AIA Document G701™ – 2001

Change Order

PROJECT: <i>(Name and address)</i> La Cienega Fire Station #1 14 Fire Place Road Santa Fe, New Mexico 87508	CHANGE ORDER NUMBER: 001 DATE: December 3, 2013 ARCHITECT'S PROJECT NUMBER: 2013-0176-PW	OWNER ☒ ARCHITECT ☒ CONTRACTOR ☒ FIELD ☐ OTHER ☐
TO CONTRACTOR: <i>(Name and address)</i> HON & R2 Architectural Design 730 San Mateo Blvd. SE Albuquerque, NM 87108	CONTRACT DATE: June 11, 2013 CONTRACT FOR: Architectural Services

CCP #10: Install New Domestic Water and Fire Lines

SANTA FE COUNTY
 UTILITIES DEPARTMENT
 WATER DIVISION
LA CENEGA FIRE STATION
 OFFSITE MASTER UTILITY PLAN

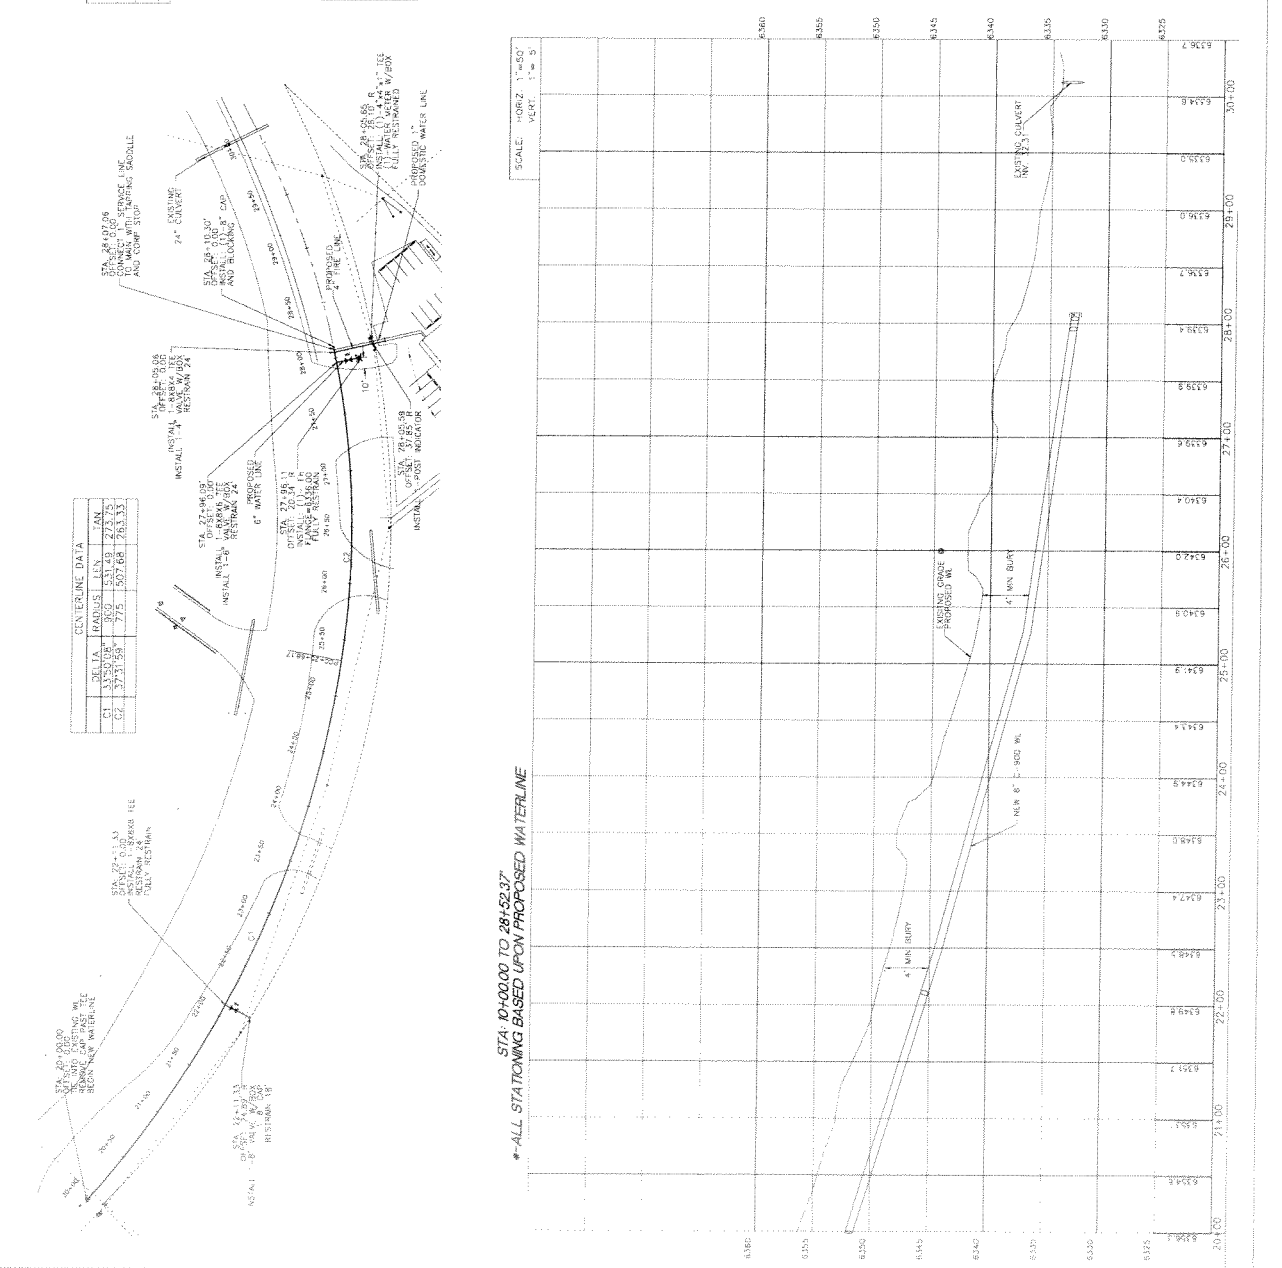
Submit a proposal for increased cost and contract time to extend new fire and domestic water lines from the street to the facility per the 'Utility Improvements' plans provided by Rio Grande Engineering dated 11/13/13. This scope has been discussed and approved with the Owner, Architect, and Contractor in the field.
